EDGEWATER REDEVELOPMENT

SUBMITTAL PACKAGE
URBAN DESIGN COMMISSION

SUBMITTED BY:
LANDMARK X, LLC
A WISCONSIN LIMITED LIABILITY COMPANY

DESIGN EVOLUTION – INTEGRATION OF UDC COMMENTS

BUSES AND SERVICE VEHICLES

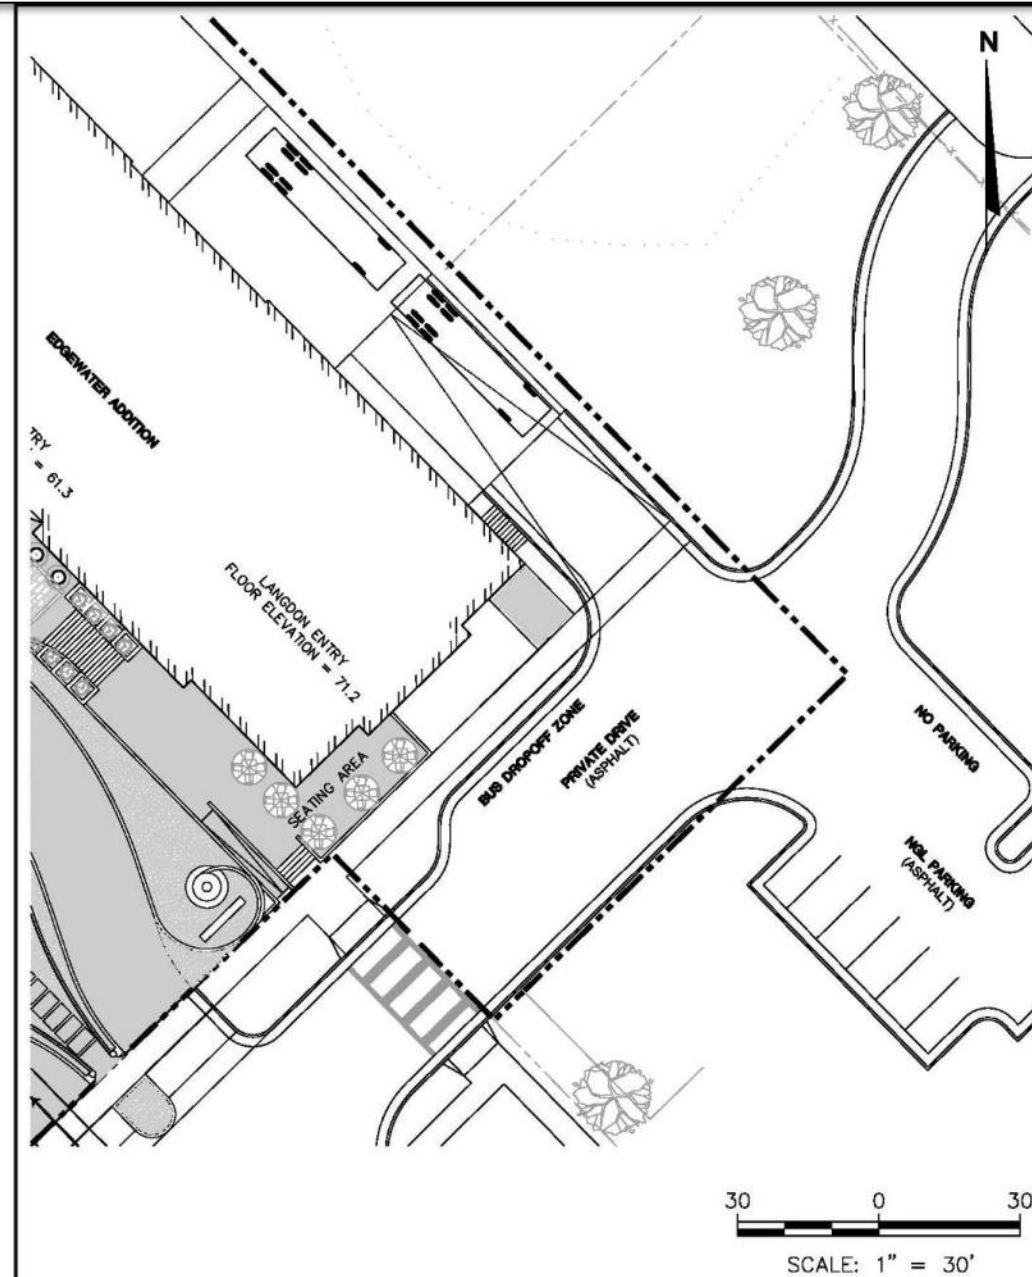
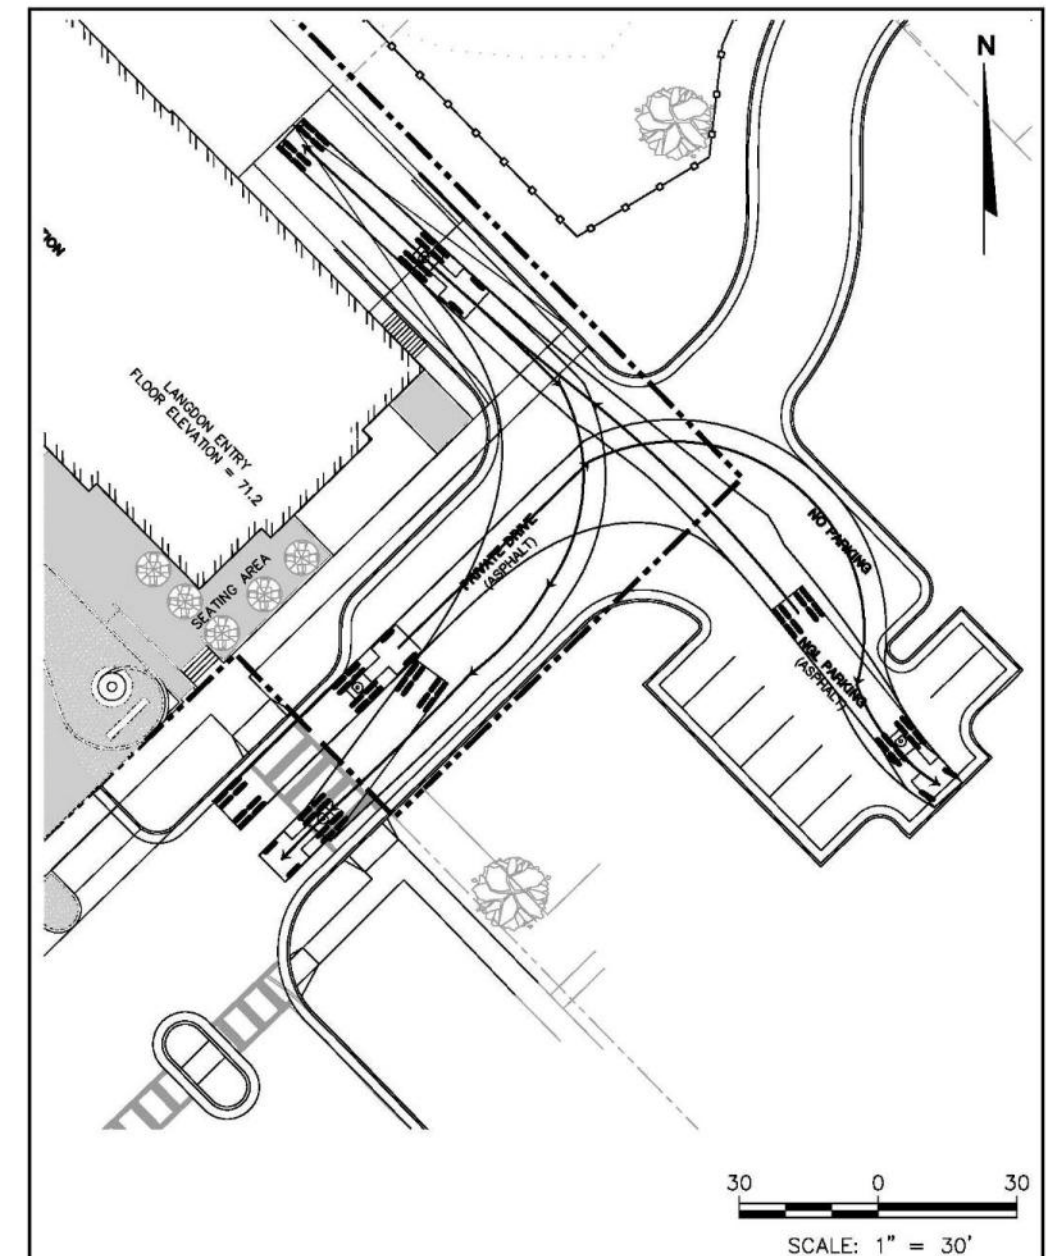
| <input checked="" type="checkbox"/> | Demonstrate Bus Loading / Turning | Section 7.0, Pages 22-23 |
| <input checked="" type="checkbox"/> | Demonstrate Truck Loading / Turning | Section 7.0, Pages 22-23 |

SERVICE VEHICLES WILL BE REMOVED FROM PUBLIC VIEW

LOADING DOCK WILL ACCOMODATE 2 BUSES

SHADOW STUDY

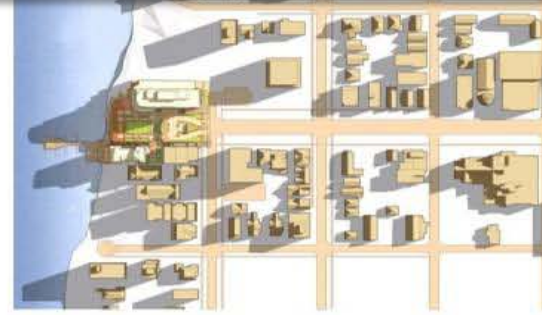
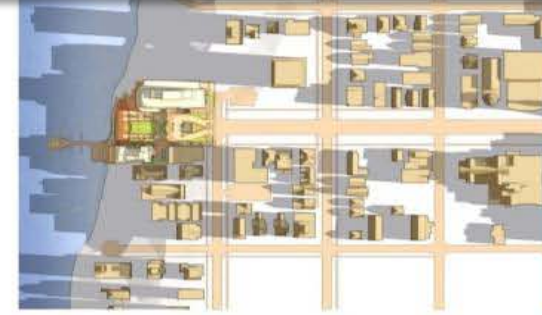
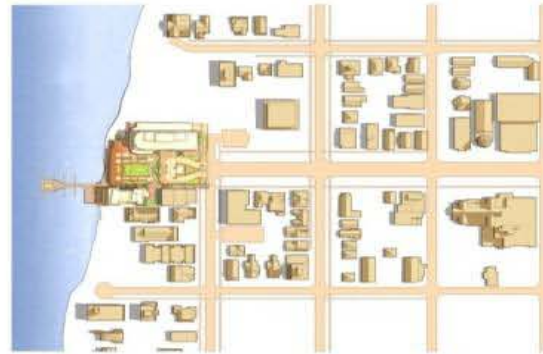
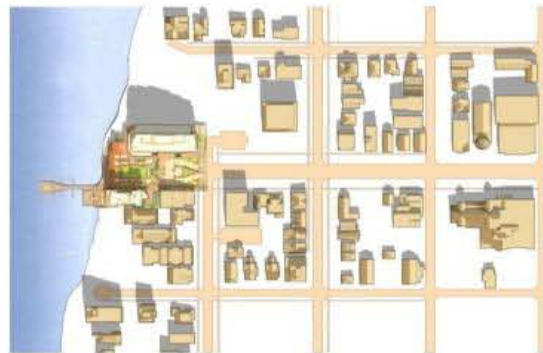
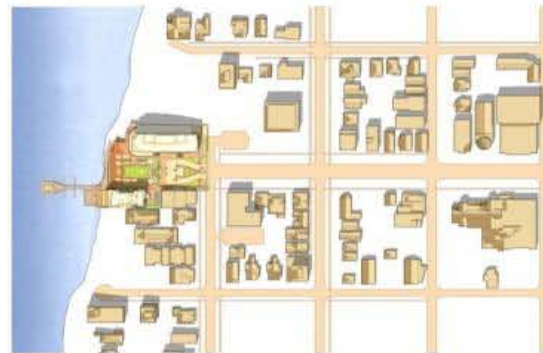
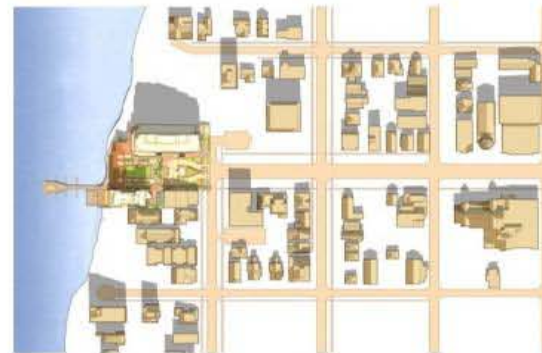
INFORMATION REQUEST – Provide a shadow study of the development.

Drawing A1.12 – Roof of New Tower

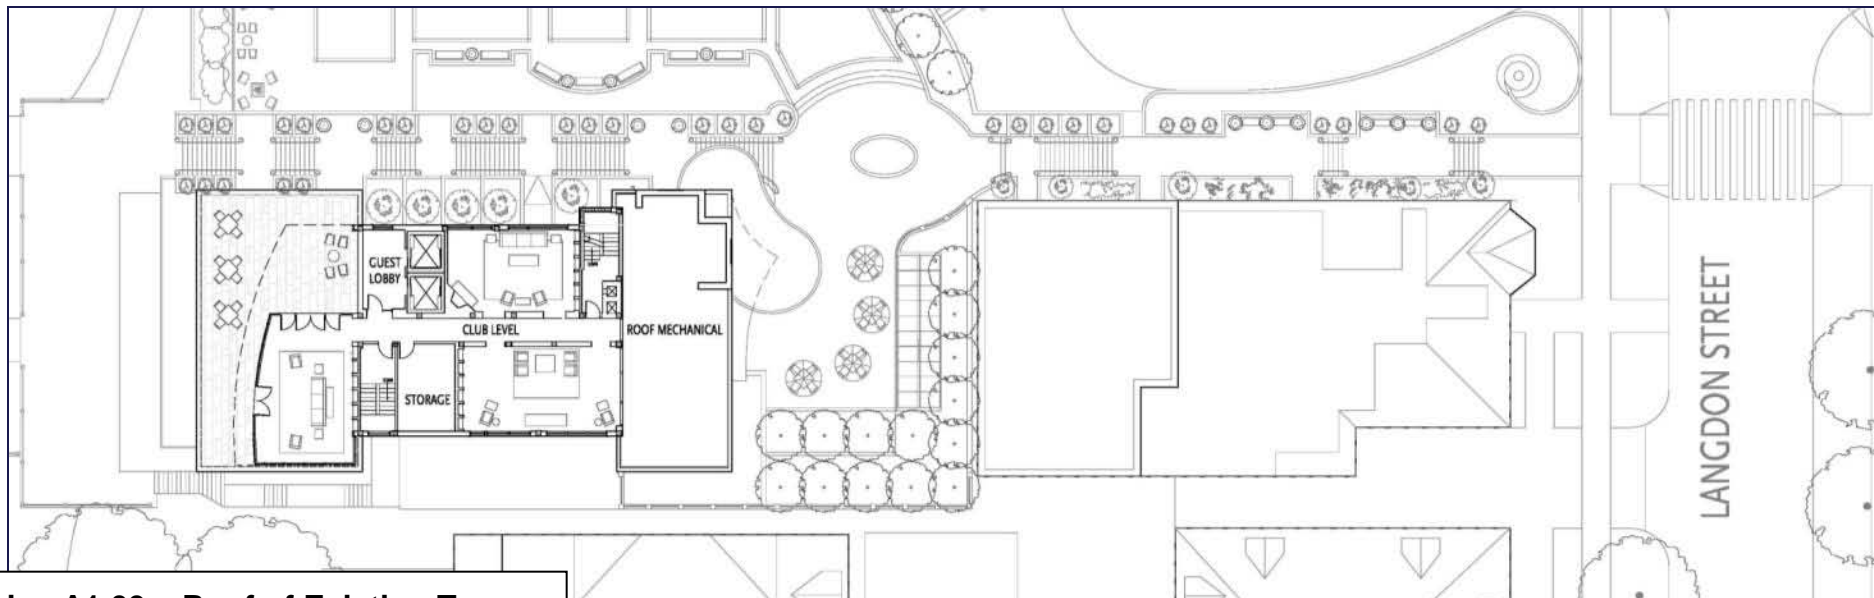
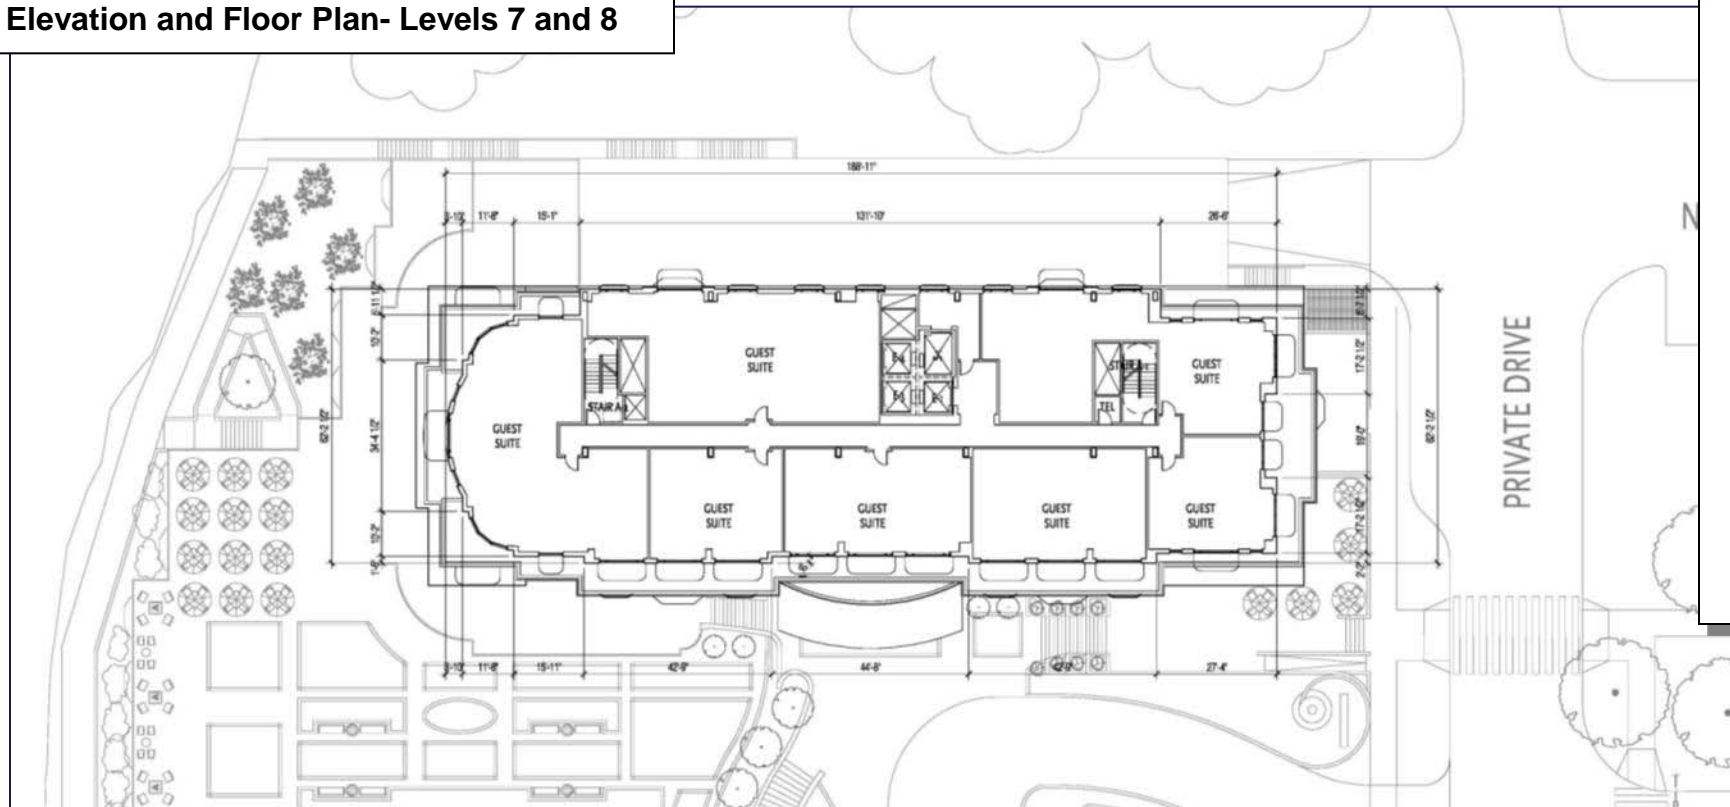
INFORMATION REQUEST – Clarify locations of roof-top installations

- Roof top mechanicals, cooling towers and elevator over-runs are enclosed /shielded by Penthouse;
- Secondary locations for roof-top installations are located adjacent to penthouse on new tower;
